PROPOSED ASME CC N-830-1

DIRECT USE OF FRACTURE TOUGHNESS FOR FLAW EVALUATIONS OF PRESSURE BOUNDARY MATERIALS IN CLASS 1 FERRITIC STEEL COMPONENTS

**Meeting with USNRC
January 13, 2020**

Changes to the T_{US} Linkage Model

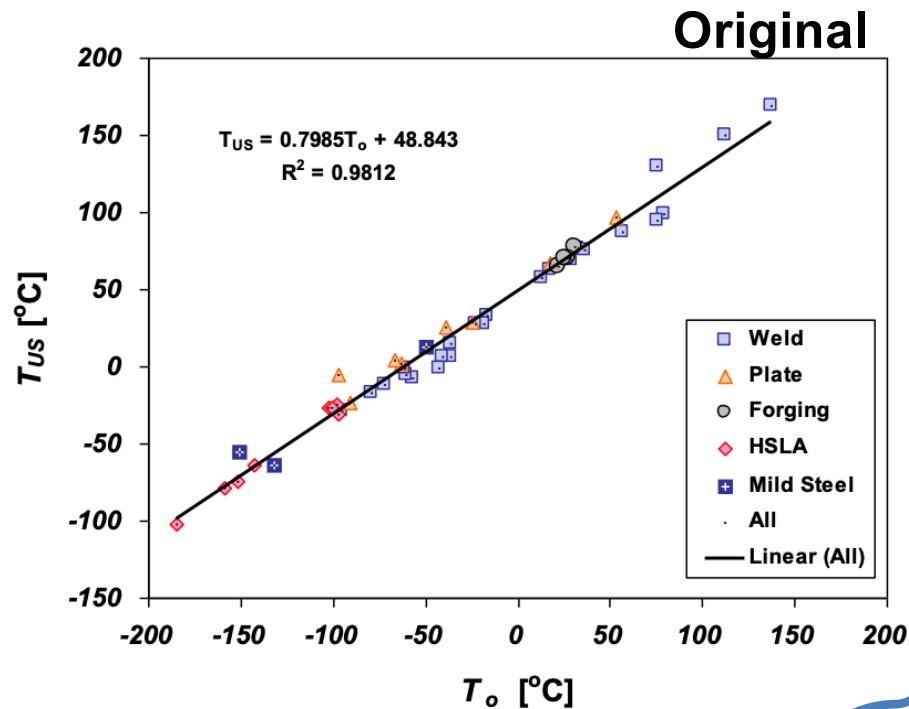
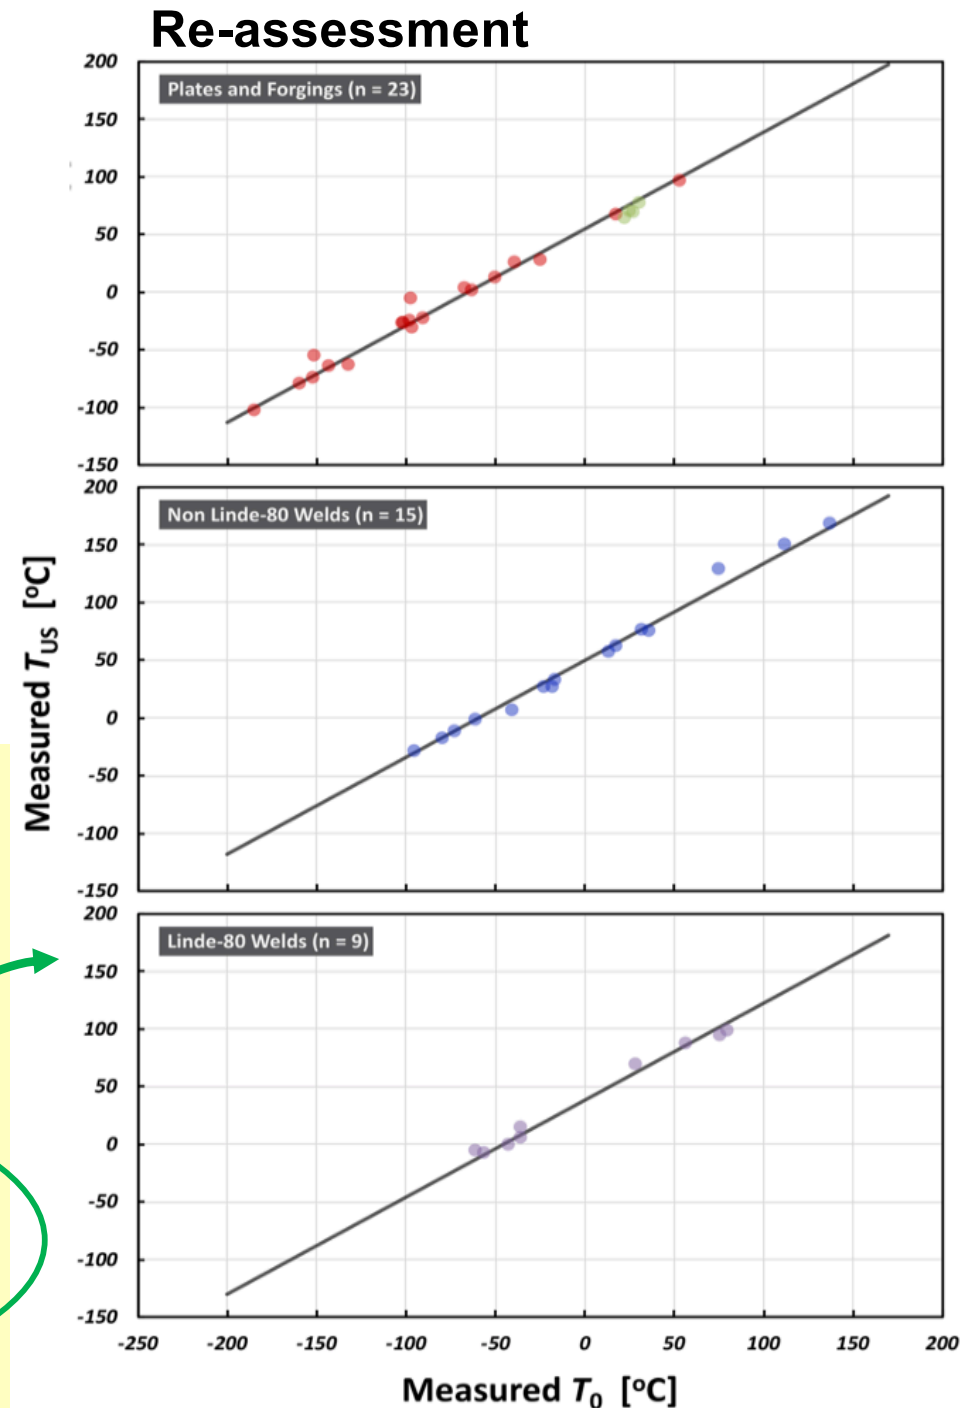
- Effect of product form not assessed in model development resulted in:

$$T_{US} = 48.843 + 0.7985T_0$$

- Statistical reassessment of product form:

$$T_{US} = b_{PF} + 0.84T_0$$

where b_{PF} has units of °C and has the following values:

- +54.5 °C for plates and forgings
- +49.5 °C for non-Linde 80 welds
- +38.0 °C for Linde 80 welds
